#### ADDENDUM NO. 4 TO THE PROJECT MANUAL

## NEW RIVER CANAL TILTING WEIR ASCENSION PARISH, LOUISIANA

#### PARISH PROJECT NO. EAD 15-004 HDCA PROJECT 20121-14

**NOVEMBER 9, 2022**

SHEET ID 01-E2

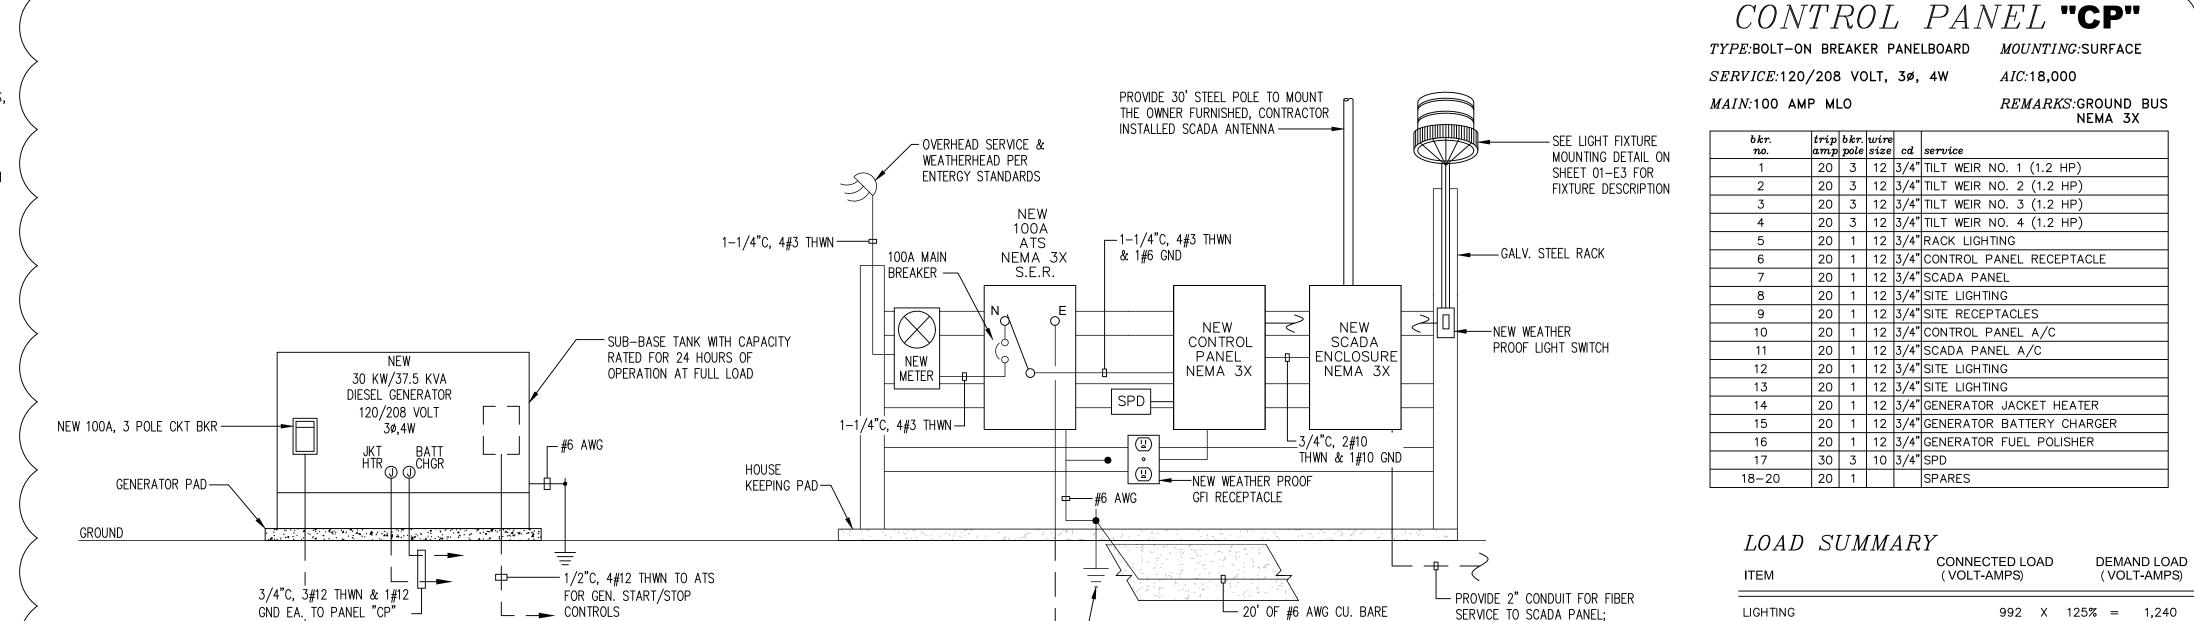
- C1. The automatic transfer switch shall be rated for 100A as per the riser diagram on Sheet 01-E2
- C2. The preferred control panel manufacturer for Ascension Parish is I.C.E. Sales & Service, LLC located in Des Allemands, LA. This is the same preferred manufacturer of the SCADA panel.

01-E4

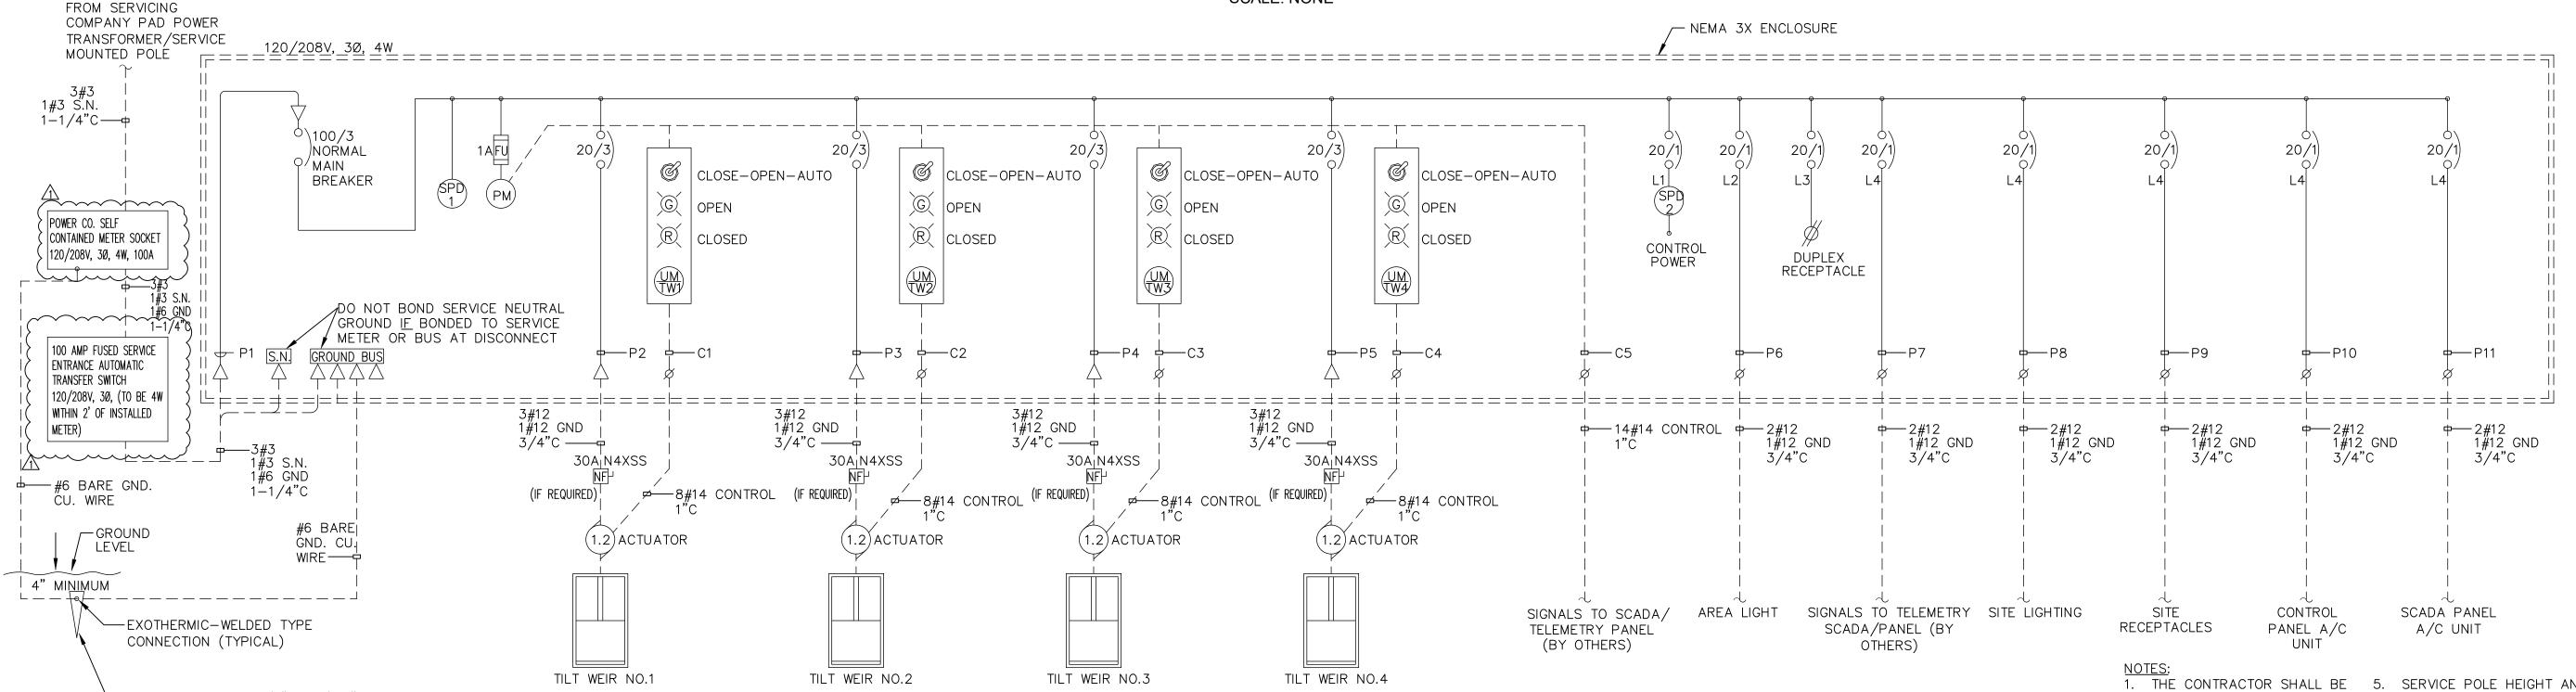
- D1. Sheet 01-E4: Updated the 200A manual transfer switch shown on the one-line diagram to be a 100A automatic transfer switch to match riser diagram on Sheet 01-E2. Updated the verbiage for the meter on the one-line diagram to read correctly.
- D2. Re-issued Sheets 01-E1, 01-E2, 01-E3, and 01-E4 for clarity.
